# 1989 Corvette: Service Bulletin: Tire Rotation Procedure

**Subject:** Tire Rotation Procedure

**Model and Year:** 1989 Y Car with Optional Low Tire Pressure Warning System

**Number:** 89-299-3E

Figure 1 - Tire Rotation Pattern

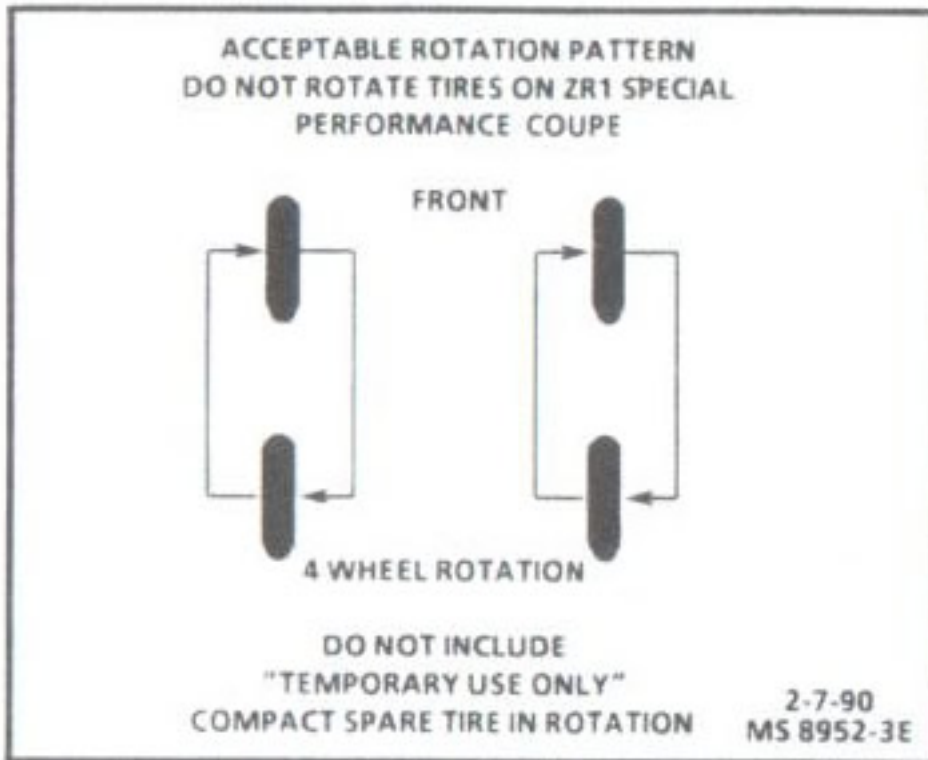
The Low Tire Pressure Warning System receiver does not recognize wheel/tire assembly location; however it does look for a particular signal from each of the four wheel transmitter/sensors. Therefore, the procedure given on the tire rotation in Section 3E of the 1989 "Y" Carline Service Manual should be disregarded. The tire and wheel assemblies on vehicles equipped with the optional Low Tire Pressure Warning System can be rotated as show in Figure 1.
